APPLICATION NO.	FILING DATE	FIRST NAMED INVENTOR	ATTORNEY DOCKET NO.	CONFIRMATION NO.
10/605,717	10/21/2003	Shang-Kung Tsai	ADTP0069USA	2716
27765	7590	02/23/2005	EXAMINER	
NORTH AMERICA INTERNATIONAL PATENT OFFICE (NAIPC) P.O. BOX 506 MERRIFIELD, VA 22116			CHOWDHURY, TARIFUR RASHID	
			ART UNIT	PAPER NUMBER
			2871	
DATE MAILED: 02/23/2005

<b>Office Action Summary</b>	Application No. 10/605,717	Applicant(s) TSAI, SHANG-KUNG	
	Examiner Tarifur R. Chowdhury	Art Unit 2871

## DETAILED ACTION

Fig.1

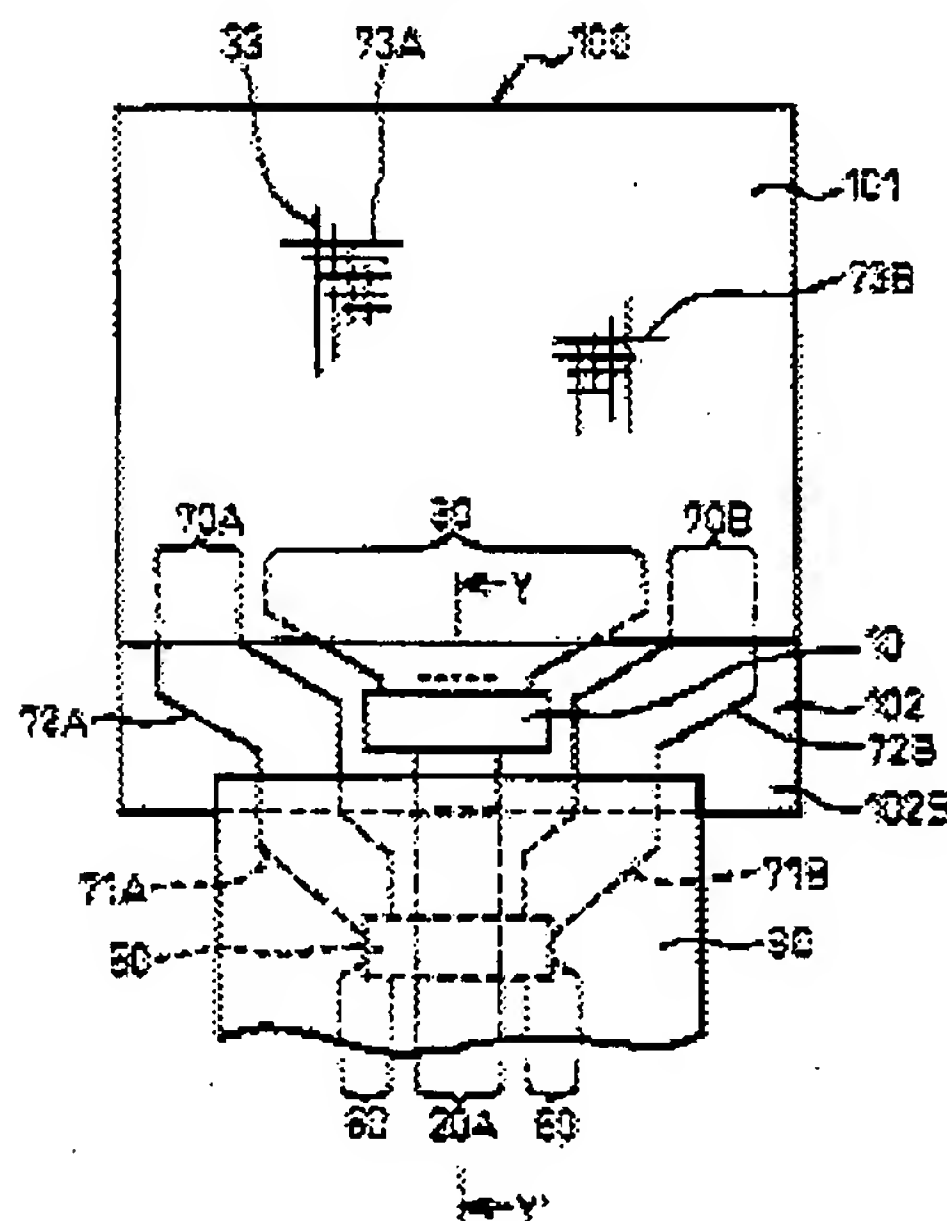
6. Togashi discloses (page 5, paragraph's: 0066-0070) and shows in Fig. 1, a liquid crystal display panel comprising:

- a glass substrate having a display area and a peripheral circuit area positioned on a surface of the substrate;
- at least a first driver IC (10) positioned on the peripheral area of the substrate;
- a flexible printed circuit board (90) positioned at the outside perimeter of the peripheral circuit area on the same side as the first driver IC (10), the flexible circuit board having an extension portion comprising at least a second driver IC (50); and
- a plurality of conductive wires connected to the first driver IC, the second driver IC, and the display area of the substrate.

Accordingly, claims 6 and 12 are clearly anticipated.

As to claim 9, it is clear from Fig. 1 that the substrate is a rectangular.

9. As to claims 1-5, 7, 8, 10 and 11, Togashi discloses and shows in Fig. 1 that the liquid crystal display panel (100) is a symmetrical liquid crystal display panel and can be applied to portable telephones (cell phones) (page 1, paragraph 0004). Togashi discloses a passive matrix type liquid crystal display and thus fails to explicitly disclose that the liquid crystal display panel is an amorphous silicon thin film transistor liquid crystal display panel and that the first and second driver IC's are source and gate driver IC's respectively. However, it is common and well known in the art to use an active matrix liquid crystal display panel using amorphous silicon thin film transistors and wherein the gate line driver circuits are known as gate driver IC and the data line driver circuits are known as data/source driver IC for several advantages such as to reduce crosstalk. Therefore, it would have been obvious to one of ordinary skill in the art at the time of the invention was made to use the passive matrix display panel of Togashi as an active matrix display panel for advantages such as to reduce crosstalk.
